March 10, 2023

Project Name: PEARL JUNIOR HIGH MULTIPURPOSE
Project No: 22-056
RE: Updated Civil and Structural drawings.

ADDENDUM NO. 01

NEW ADDITION - CMU WALL PLAN
1/8" = 1'-0"

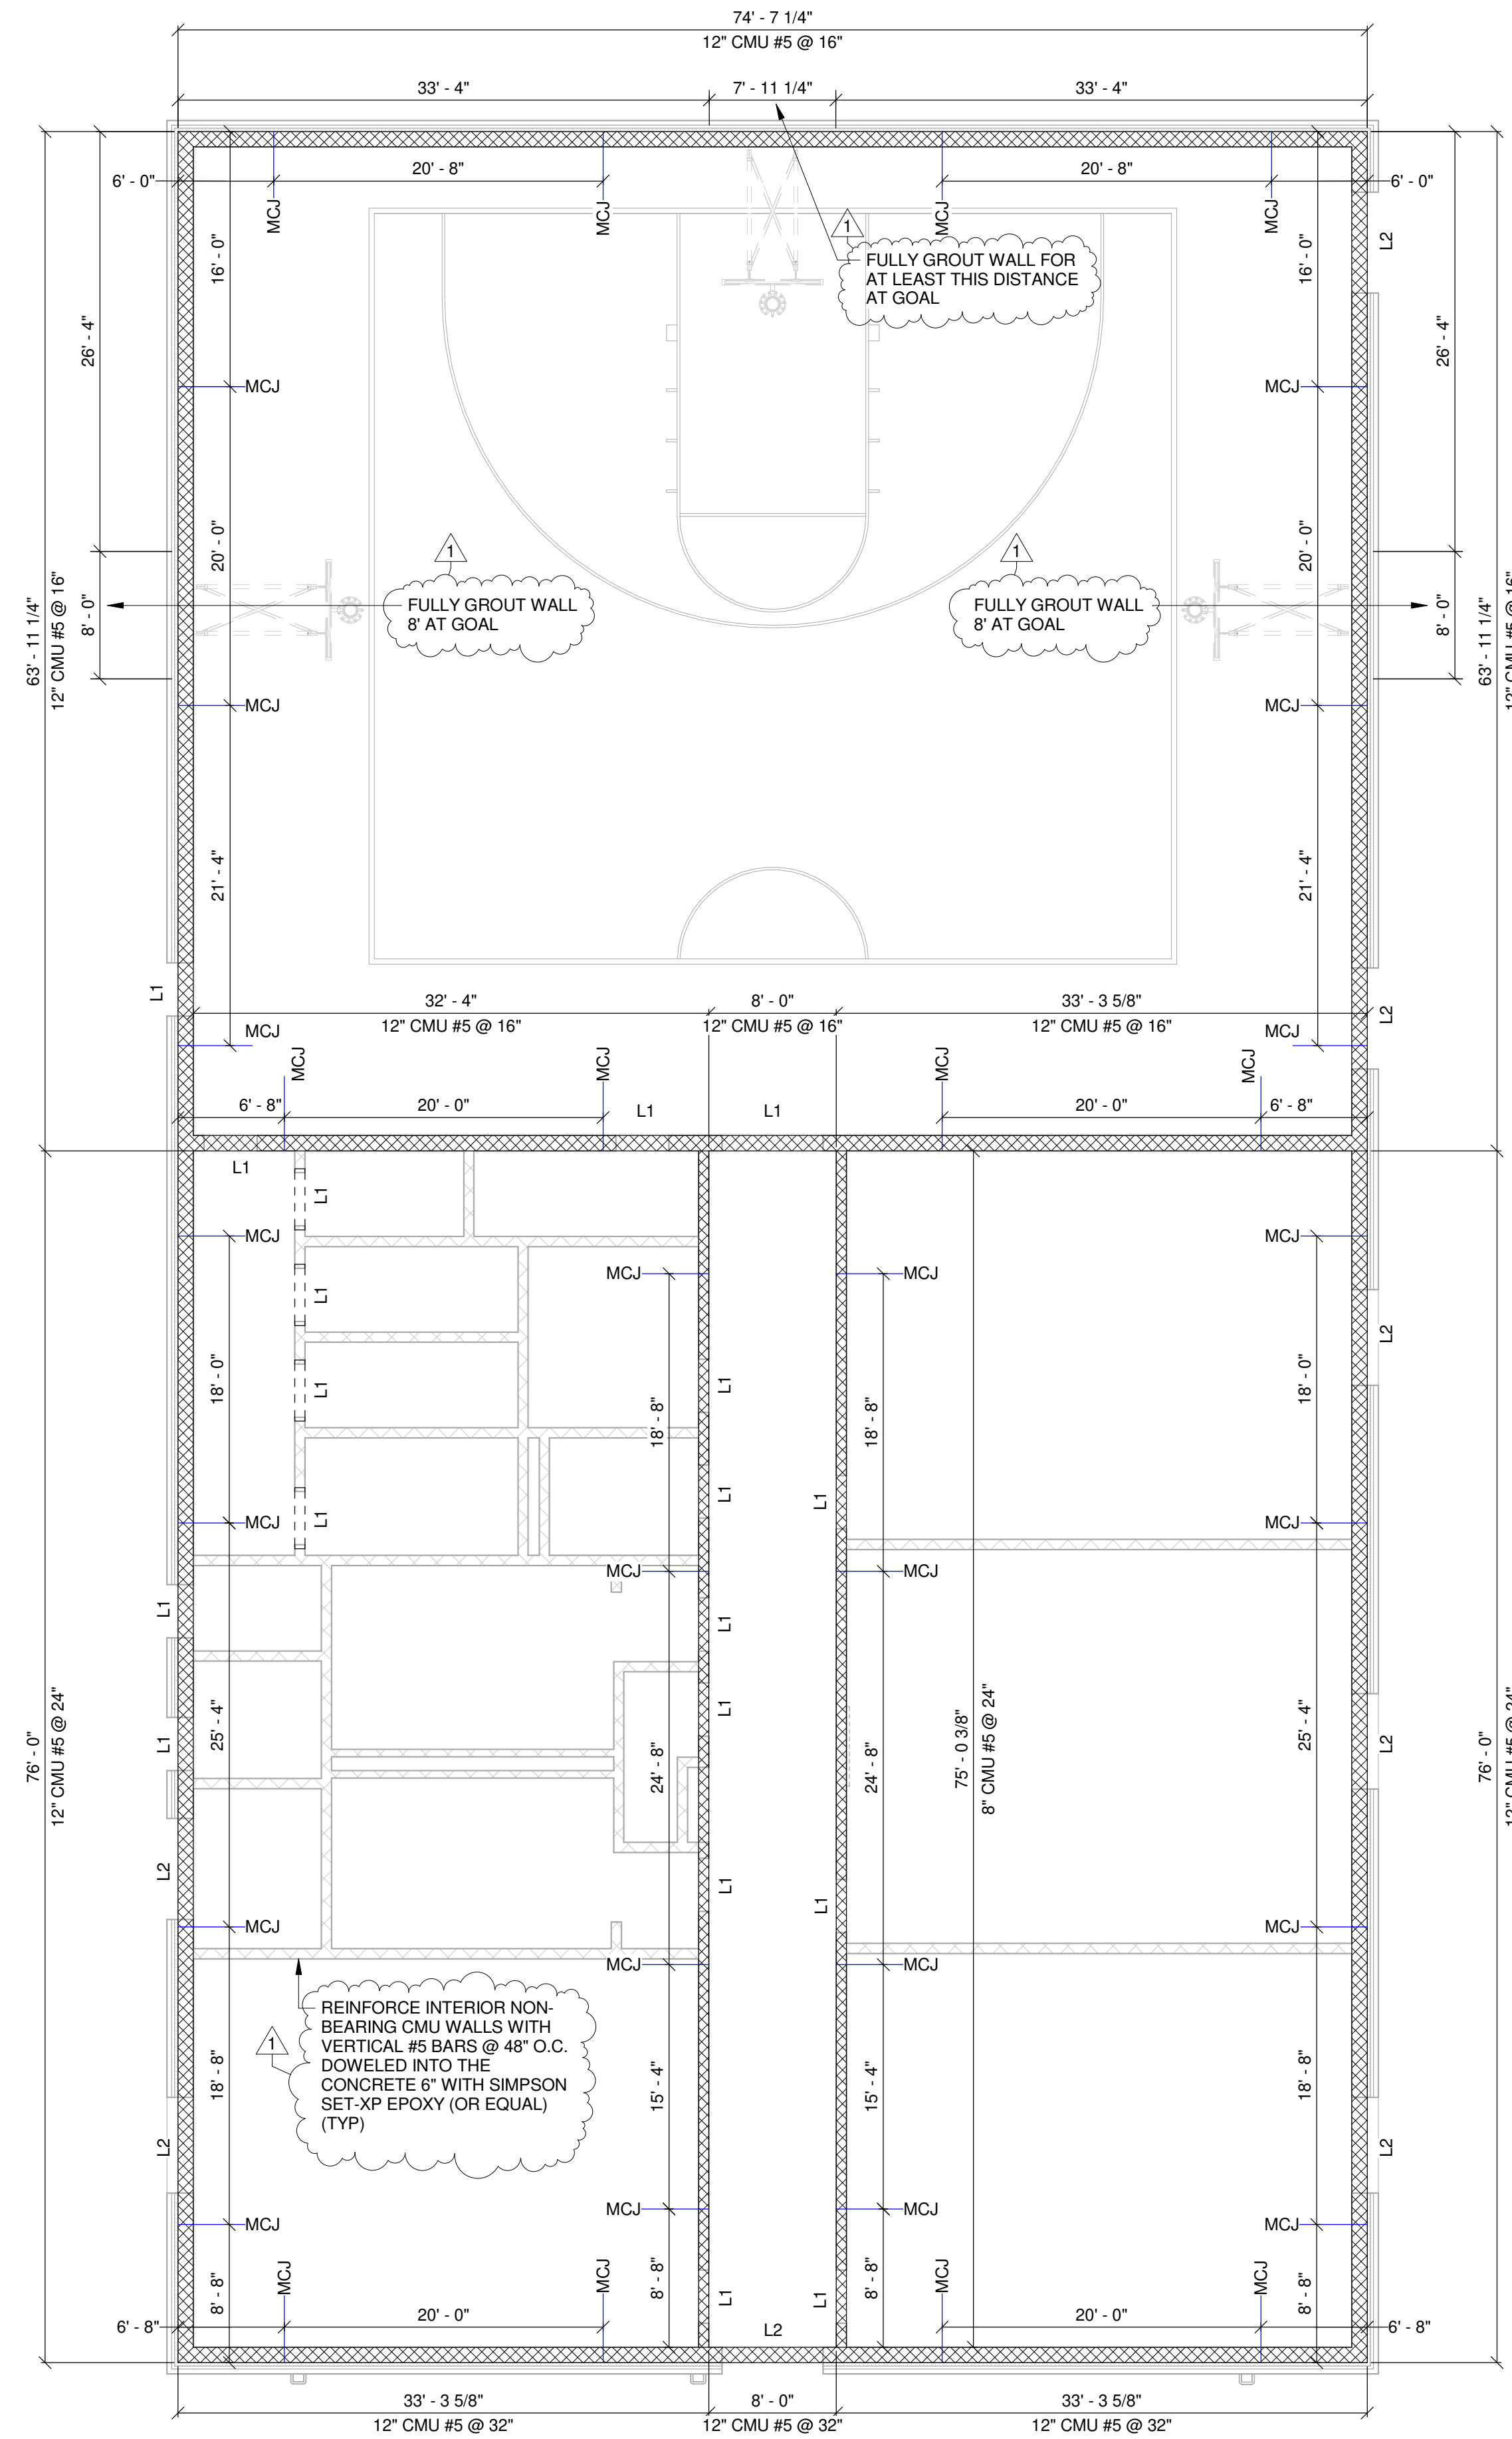
- Modified allowable drilled pier bearing capacity and added void form note.
 - S201 NEW ADDITION FOUNDATION PLAN
 - Revised reinforcement designation.
 - S202 NEW ADDITION CMU WALL PLAN

- Modified CMU wall reinforcement.
 - S203 NEW ADDITION LOWER ROOF FRAMING PLAN
 - Modified lower roof framing and added information for mechanical screen.

NEW ADDITION - UPPER ROOF FRAMING PLAN
1/8" = 1'-0"

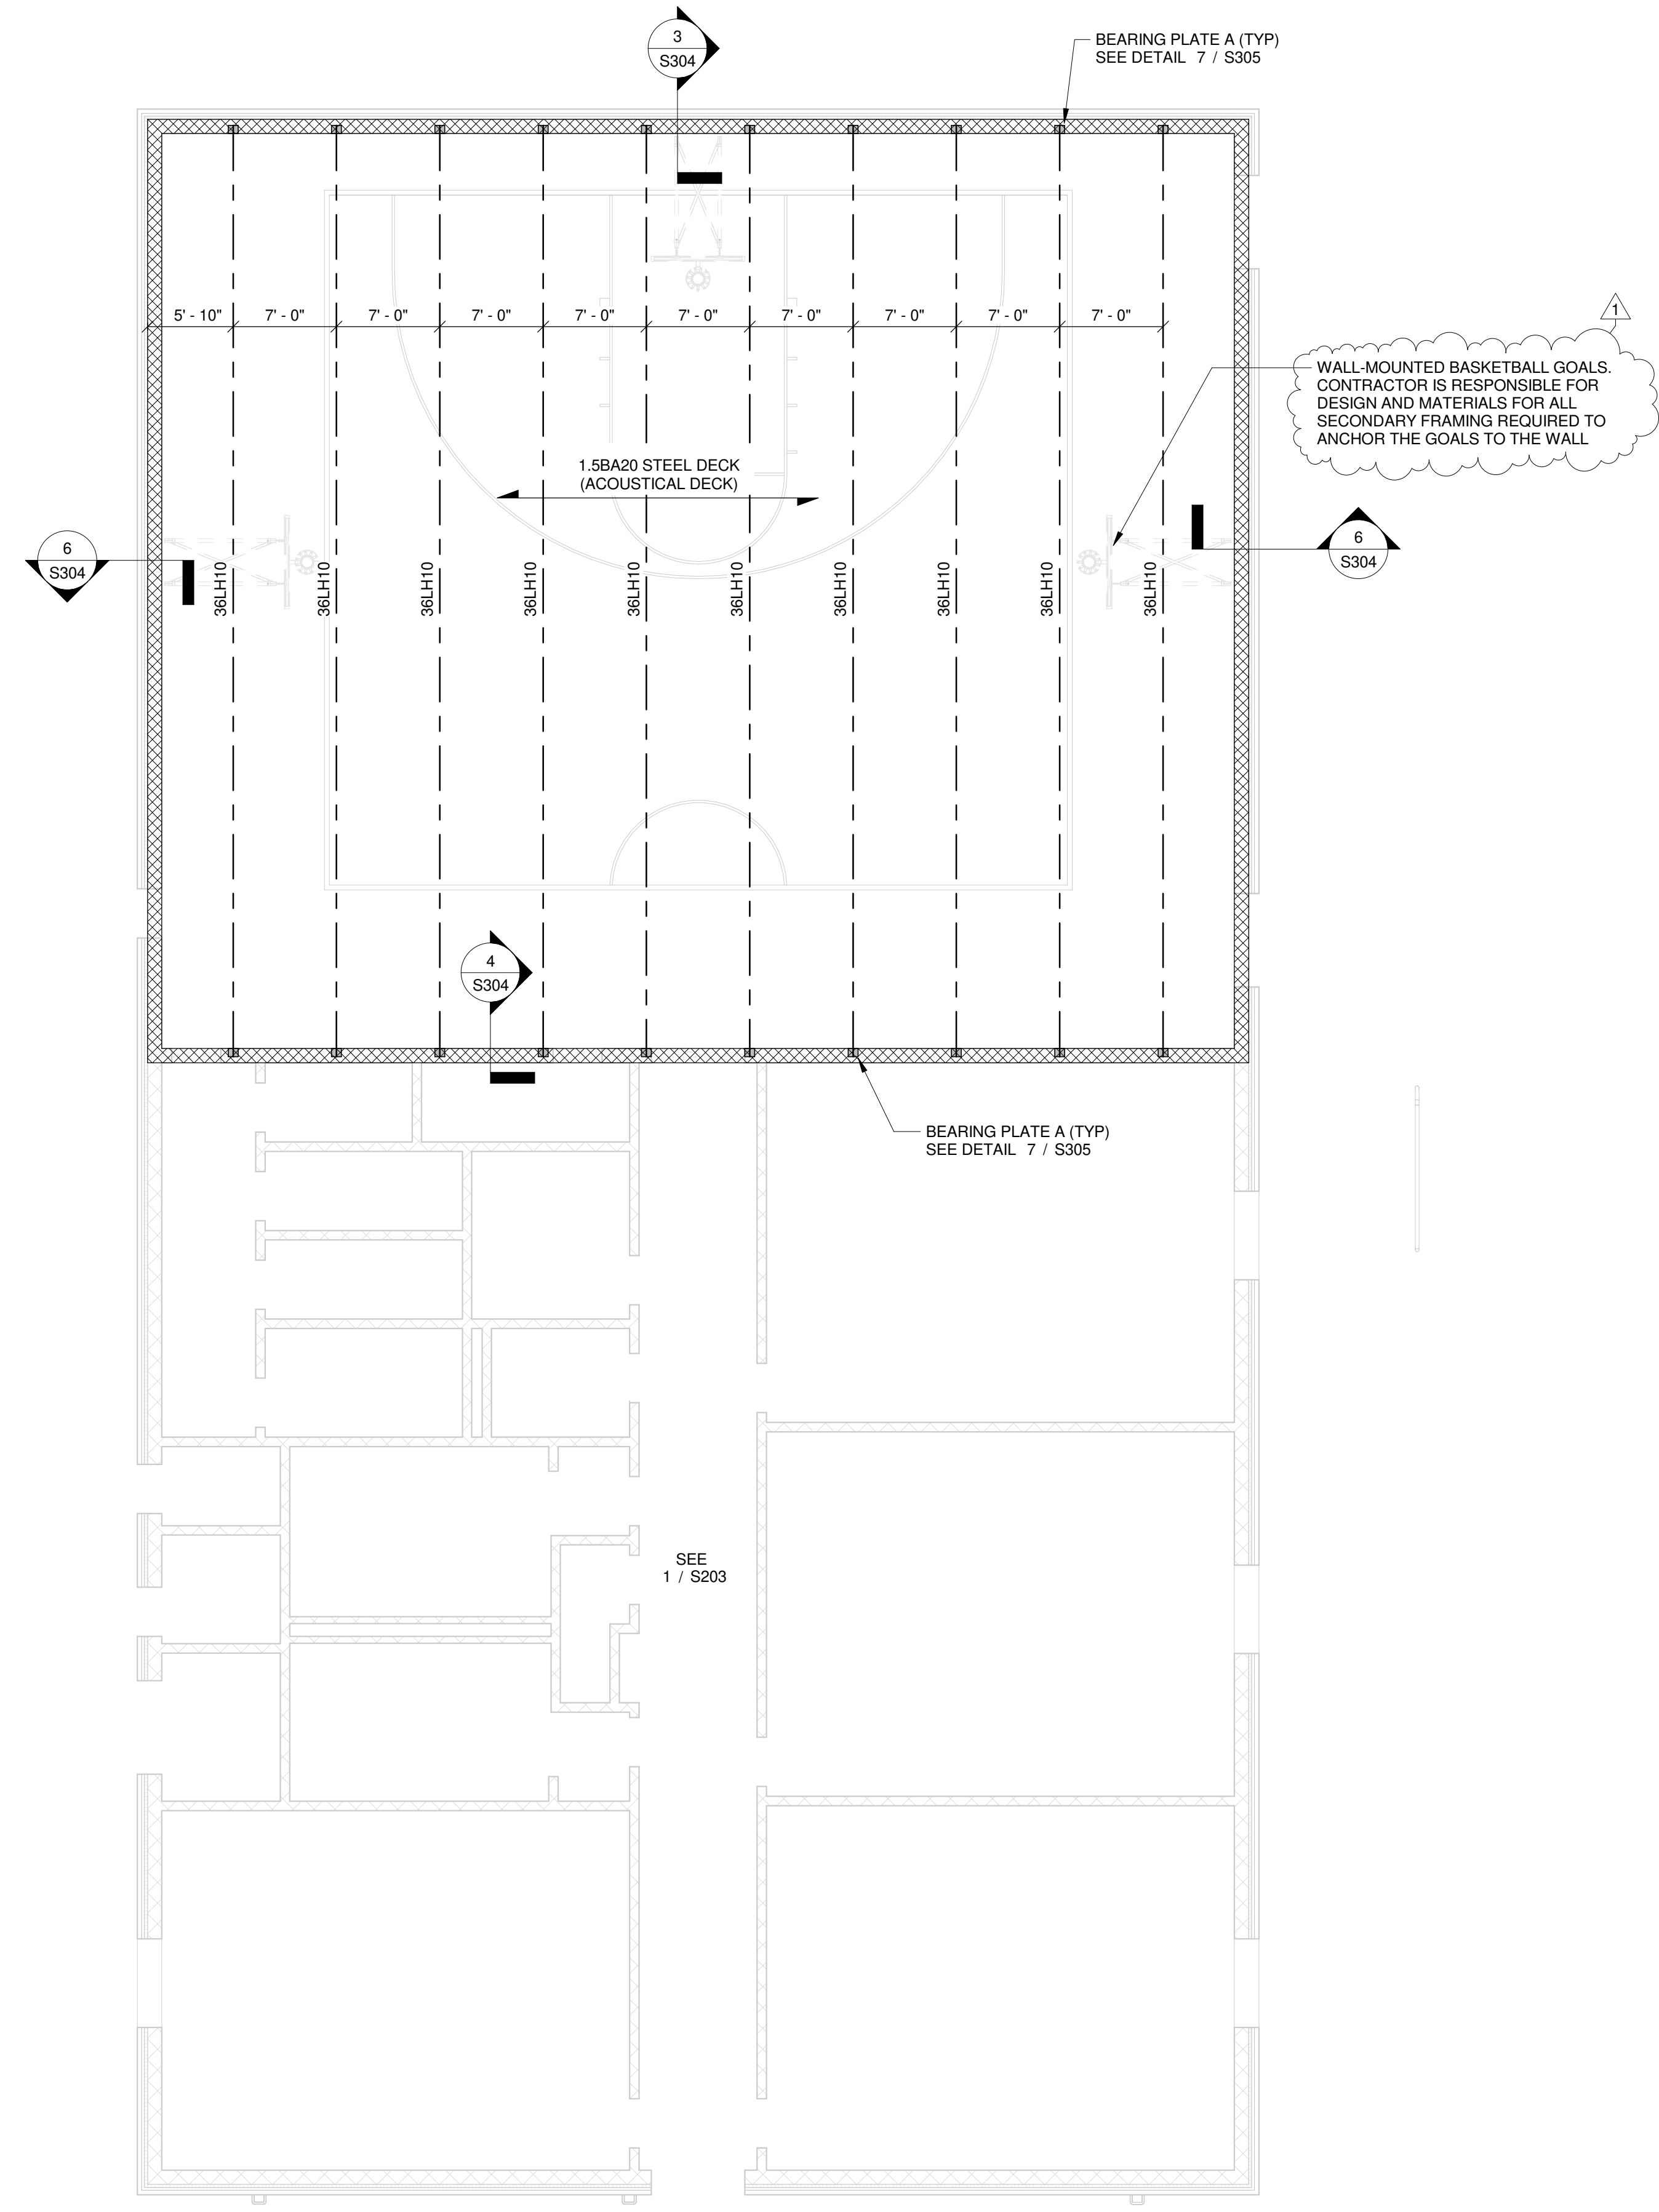
- S204 NEW ADDITION UPPER ROOF FRAMING PLAN
 - Modified basketball support condition.
 - S205 BASEMENT FOUNDATION PLAN – ALTERNATE 1
 - Modified information for cutting into existing grade beam for new door and added dimensions for exterior stairs.
